COUNCIL ASSESSMENT REPORT

SYDNEY EASTERN CITY PLANNING PANEL

PANEL REFERENCE & DA NUMBER	PPSSEC-304 – DA/2023/1125
PROPOSAL	Integrated development for construction of a two-storey recreational club facility including rowing boatshed, publicly accessible boat launching pontoon, kiosk and ancillary spaces.
ADDRESS	Part Lot 120 DP 1279860 – 66-68 Mary Street LILYFIELD
APPLICANT	Barbara Ramjan
OWNER	Crown Lands
DA LODGEMENT DATE	27 December 2023
APPLICATION TYPE	Development Application (Integrated)
REGIONALLY SIGNIFICANT CRITERIA	Section 2.19(1) and Clause 5 of Schedule 6 of <i>State Environmental Planning Policy (Planning Systems) 2021</i> declares the proposal regionally significant development as: Private infrastructure and community facilities over \$5 million
CIV	\$9,350,821 (excluding GST)
CLAUSE 4.6 REQUESTS	N/A
KEY SEPP/LEP	<ul style="list-style-type: none"> • <i>State Environmental Planning Policy (Biodiversity and Conservation) 2021</i> • <i>State Environmental Planning Policy (Sustainable Buildings) 2022</i> • <i>State Environmental Planning Policy (Planning Systems) 2021</i> • <i>State Environmental Planning Policy (Resilience and Hazards) 2021</i> • <i>State Environmenta

Figure 1: Amended Elevations (Dwg DA 2.20 rev C prepared by Hill Thalys dated 17 December 2024)

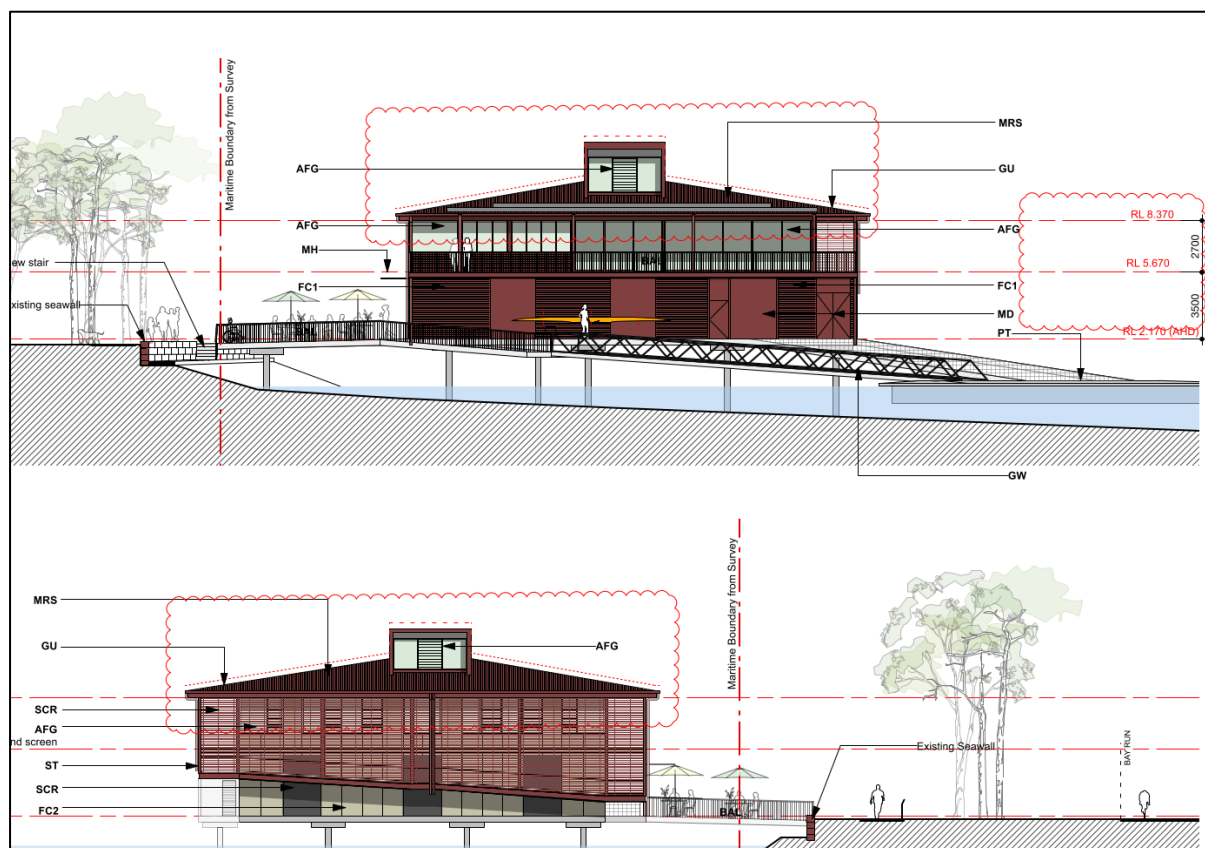
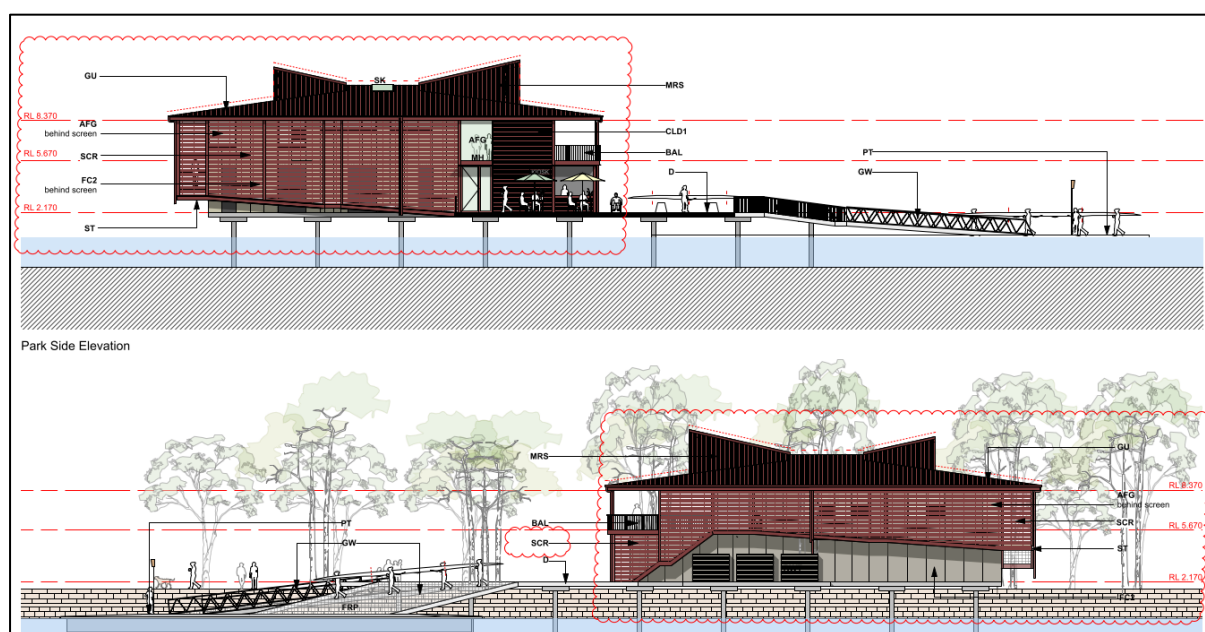
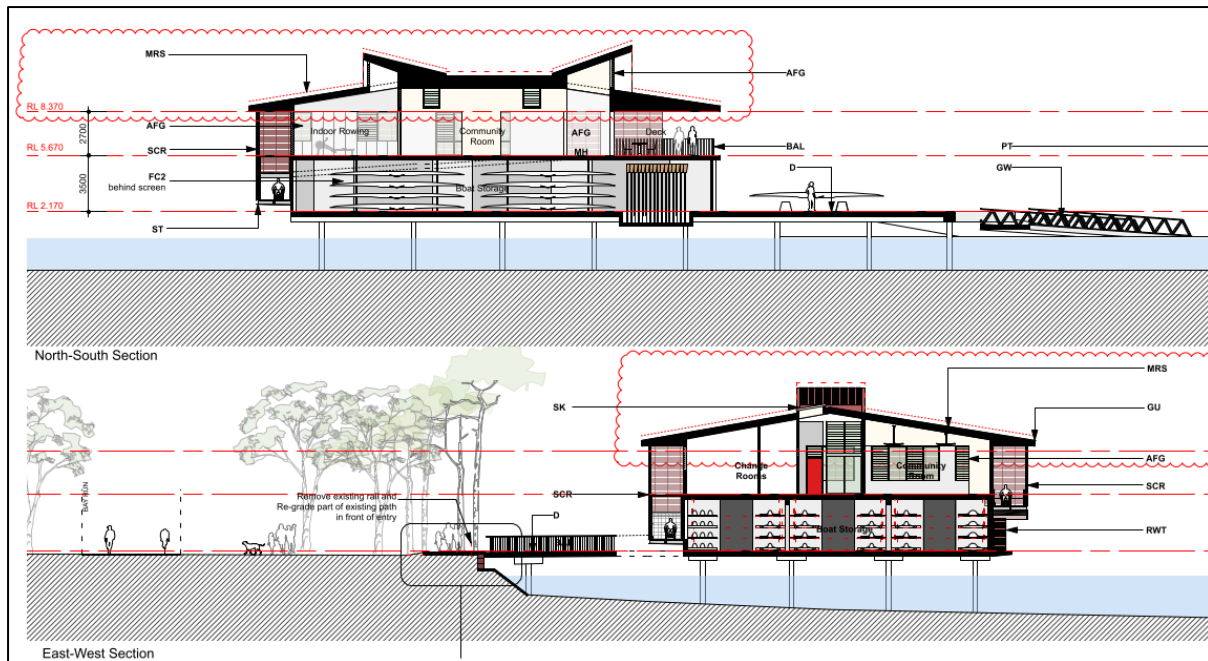
An amended set of elevations and sections (dwg DA 2.20 rev C, DA 2.21 rev B & DA 2.30 rev B, prepared by Hill Thalys dated 17 December 2024) has been submitted. The amendments include reducing the building height and gutter lines by 300mm resulting in a first floor pitching point of 2.7m and a maximum height of approximately 12.7m (RL 12.47 AHD).

Whilst the reduction in height is welcomed, it is considered that a 300mm reduction does not sufficiently respond to the visual bulk and prominence of the building on a public foreshore. It is considered that a 300mm reduction in height does not '*minimise the scale of the proposal*' in-line with the reasons for deferral and that there is scope for further reductions to be made whilst maintaining the facilities as proposed. This could include additional reductions in the first floor ceiling heights given the raked ceilings presently achieve generous ceiling heights of between 2.7m and 4m, and the consolidation of uses on the first floor with an amended roof form. It is considered that such adjustments would reduce the structure's visual prominence and better align with the relevant provisions of *SEPP (Biodiversity & Conservation) 2021* and the SHDCP 2005, ensuring that the development minimises its impact and prominence on the public foreshore and park.

The revised proposed developments' scale remains and is considered to have a significant visual presence in Leichhardt Park, especially when viewed from the adjacent parkland inconsistent with the objective of the relevant planning provisions. As outlined in the original assessment report, the location of the current proposal is located approximately 45m north of the site identified in the Leichhardt Park masterplan. This new location has resulted in the facility being located closer to recreational areas of Leichhardt Park including the 'Blue Hippo Park' and the 'Fr A Gonelli Garden' which are of high use and value by the community. As such, in this location, and as mentioned in the previous assessment report it is considered that a single storey form would satisfy the relevant planning objectives. This being consistent with the previous Architectural Excellence Design and Review Panel (AEDRP) advice as set out in the original assessment report.

Figure 5: Amended colour scheme (Dwg DA 3.10 rev B prepared by Hill Thalys dated 17 December 2024)

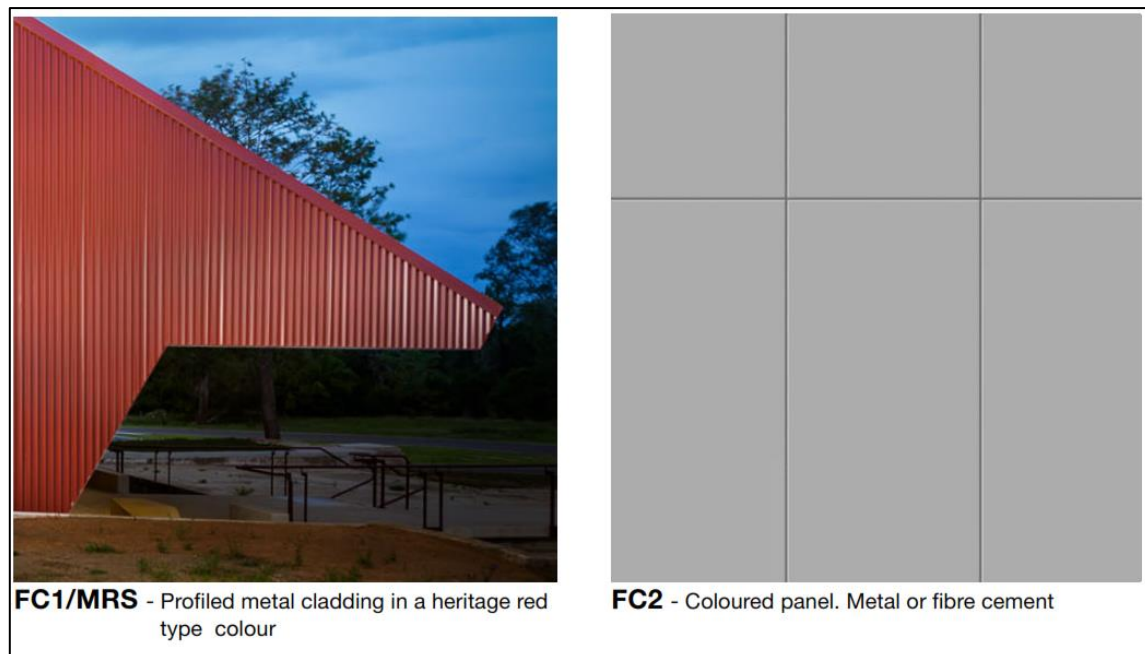
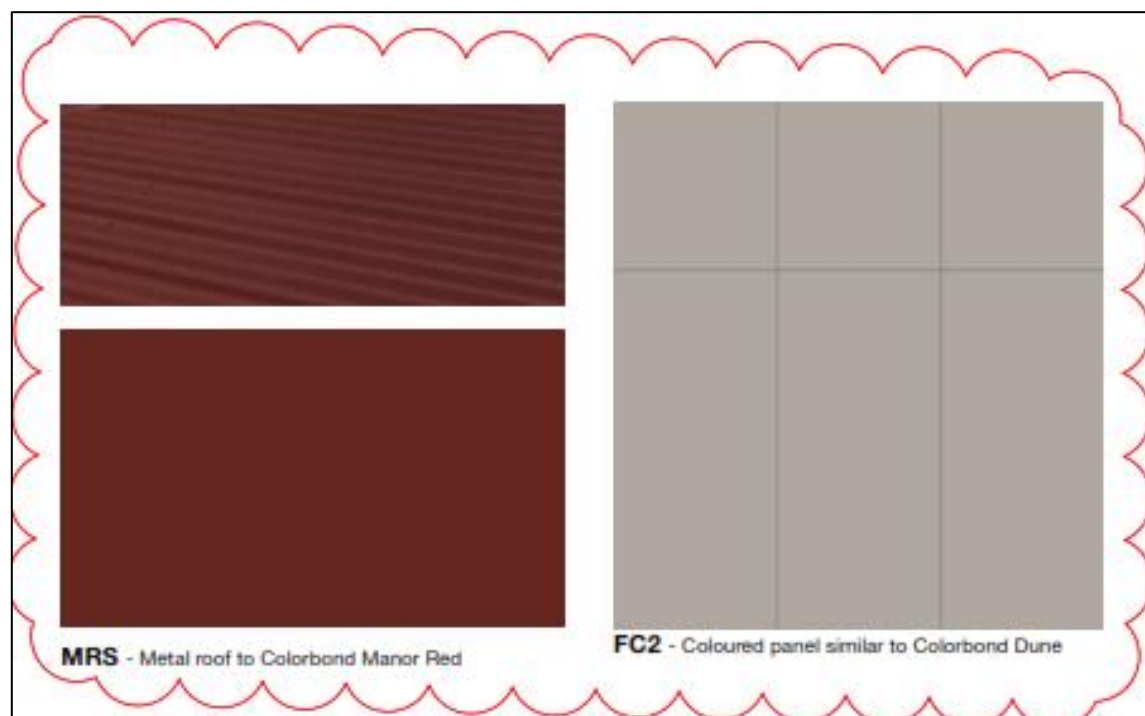
An amended materials and finishes schedule (dwg DA 3.10 rev B and dwg DA 3.11 rev B, prepared by Hill Thalys dated 17 December 2024) has been submitted. The amendments have changed the Colorbond and screening from 'Heritage Red' to Colorbond 'Manor Red', and the panels from concrete/metal to an unspecified coloured panel similar to Colorbond 'Dune'.

The applicant's justification to retain the colour red, albeit a deeper shade, is that it ties in with the terracotta roof tops visible around Iron Cove Bay and that the screening is transparent, thus reducing its prominence.

It is considered that where the development is to have the greatest visual impact is from the foreshore of Leichhardt Park. The terracotta rooftops of Haberfield, Five Dock, Rodd Point and Rodd Island are distant views physically separated from the subject site, and are not considered a prevailing characteristic of this visual catchment. Further the colour of the screening will become particularly noticeable when observed from oblique angles along the foreshore of Leichhardt Park.

It is considered that if approved, a more contextually sensitive colour scheme which aligns with the immediate landscaped setting/surrounds would be more suitable to mitigate the visual impact of the development. This is consistent with the previous Architectural Excellence Design and Review Panel (AEDRP) advice as set out in the original assessment report.

In this regard, in the event of approval, a condition is recommended to amend 'Manor Red' to any of 'Pale Eucalypt', 'Cottage Green' or 'Jasper' from the Colorbond range. Further, the proposed panel colour should be specified from a paint range (e.g. Dulux 'Beige Royal') as the material is not nominated to be Colorbond and the notation "*or similar*" be deleted to ensure that the colours are compatible with the heritage context.

Figure 7: Amended public domain plan (Dwg ASK 1.10 rev C prepared by Hill Thalys dated 24 January 2025)

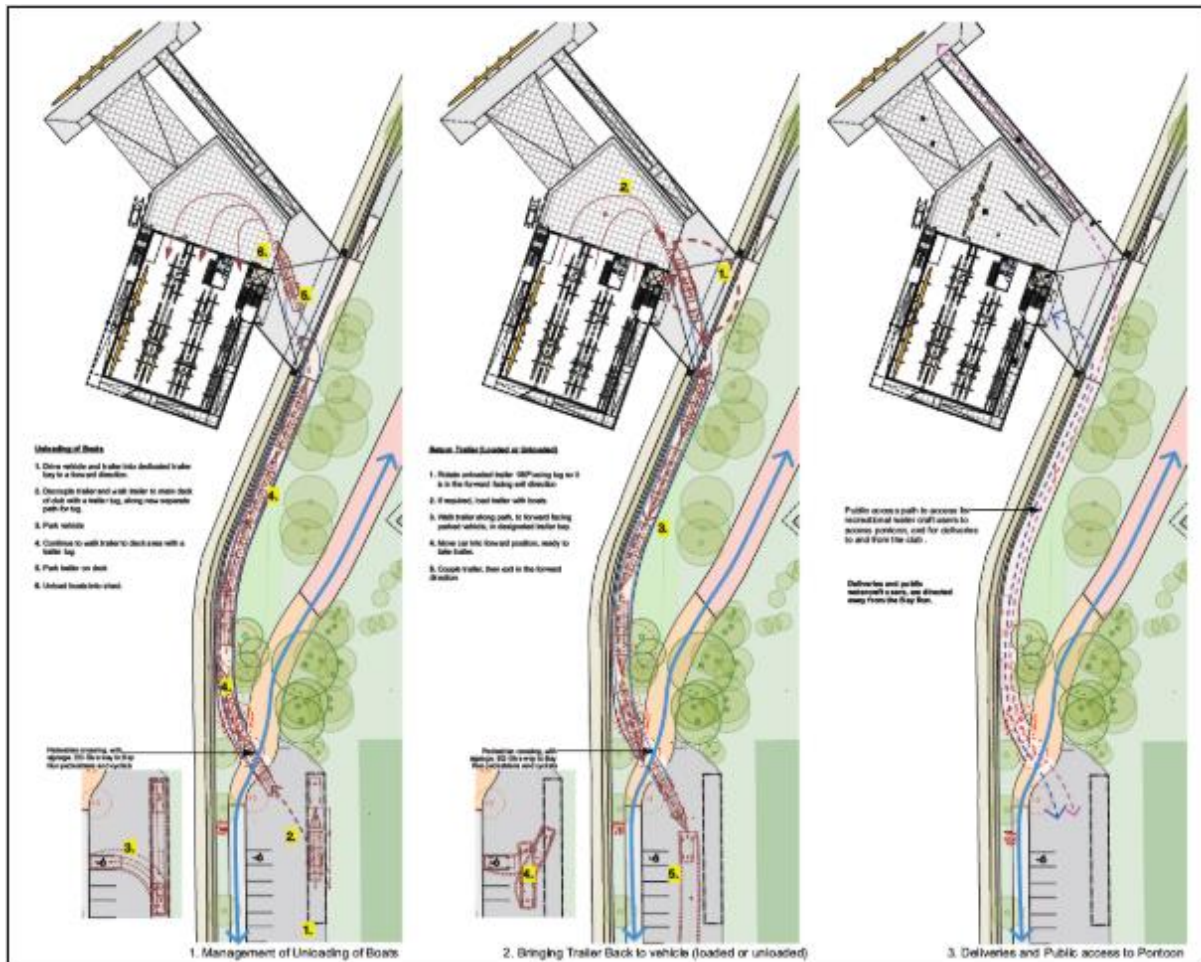
An amended public domain plan (dwg ASK1.00 rev D and ASK1.10 rev C prepared by Hill Thalys dated 24 January 2025) has been submitted. The amendments have generally been developed in consultation with Council, notably:

The public domain plan (ASK1.10 rev C, annotation number 5) shows coupling/uncoupling of the boat trailer within the parking aisle at the end of Maliyawul Street carpark which may obstruct traffic and cyclists and block access to available car spaces. In the event of approval, a condition is recommended to ensure all coupling and uncoupling of boat trailers are undertaken within the designated trailer zone.

Figure 9: Amended section detailing sea wall junction (Dwg DA 2.30 rev B prepared by Hill Thalys dated 17 December 2024)

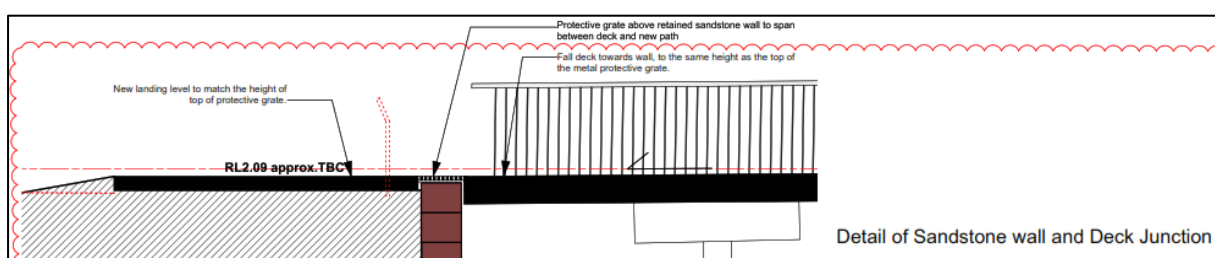
An amended Section plan (dwg DA 2.30 rev B prepared by Hill Thalys dated 17 December 2024) has been submitted. The amendments show the retention of the sandstone sea wall and adapting the footpath landing within Leichhardt Park to match the height of the top of the boat shed decking.

This amendment is accepted in that it retains the sea wall and its maintained height will protect the foreshore and open space from sea level rise or changes to flooding patterns as a result of climate change. As a result, it is considered the revised proposal satisfies the relevant provisions of Section 6.8 of the *SEPP (Biodiversity & Conservation) 2021*, and 6.6 and 5.21 within the *IWLEP 2022*.

Figure 10: Annotated ground floor plan (Dwg DA 2.10 rev E prepared by Hill Thalys dated 17 December 2024)

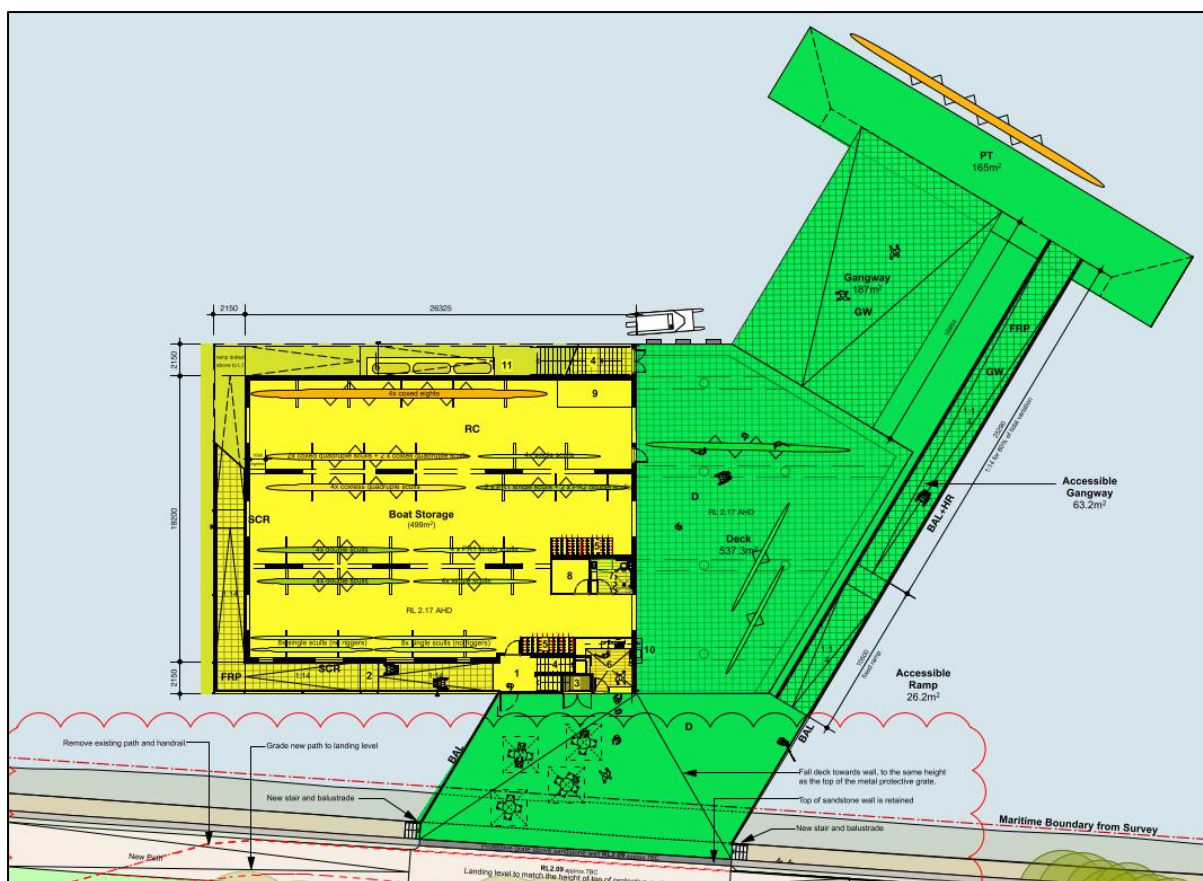
The following annotated diagram has been prepared by Council to confirm the separation of uses with yellow indicating the Recreational or club facilities and green being community facilities.

A kiosk can be ancillary to **Recreational or club facility** or **recreation facility (outdoor)** and as such is permissible. It is considered that the proposed uses are consistent with the relevant definitions and permissible with consent within the relevant zones.

Figure 1111: Attachment 2 of the addendum to the Water & Wastewater Report (prepared by Acor, dated 29 January 2025)

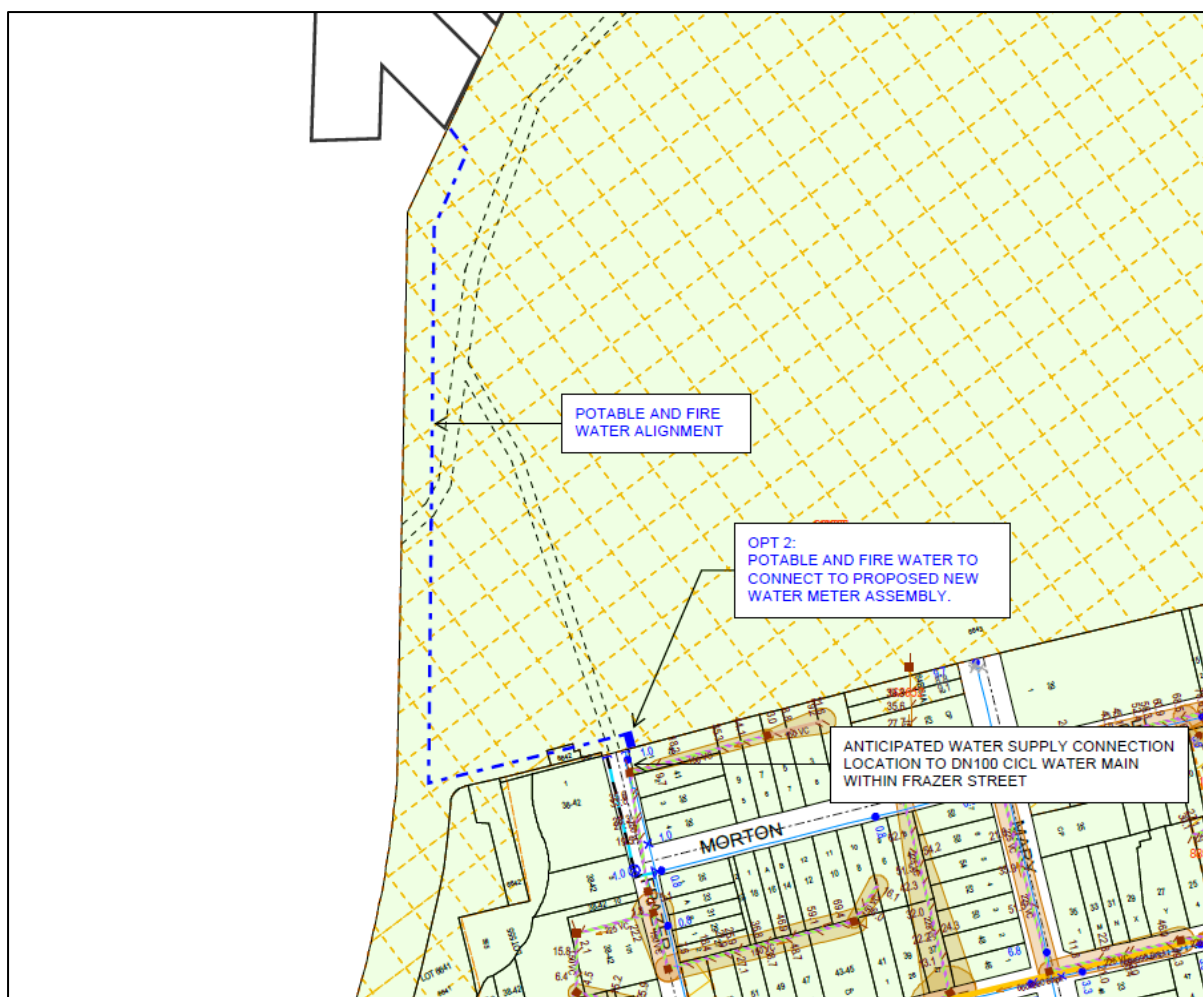
An addendum (prepared by Acor, dated 29 January 2025) to the Water & Wastewater Report was submitted. The previous report (prepared by Acor, dated 17 July 2024), identified the location of the water supply connection in close proximity to a heritage listed Fig Tree (I1201 under *IWLEP 2022*) located towards Mary Street.

It is noted that the addendum identifies a mature stand of fig trees on the hill, rather than the heritage listed fig tree adjacent to water connection at the Mary Street entrance, as such the report has not demonstrated that the preferred connection point (being option 1) has resolved the potential detrimental impact on the heritage listed fig trees.

The addendum proposes an alternative connection (attachment 2) to the existing water main located on Frazer Street. This alternate connection is accepted.

As such, the applicant has demonstrated that services that are essential for the development can reasonably be made available without adversely impacting significant trees within Leichhardt Park.
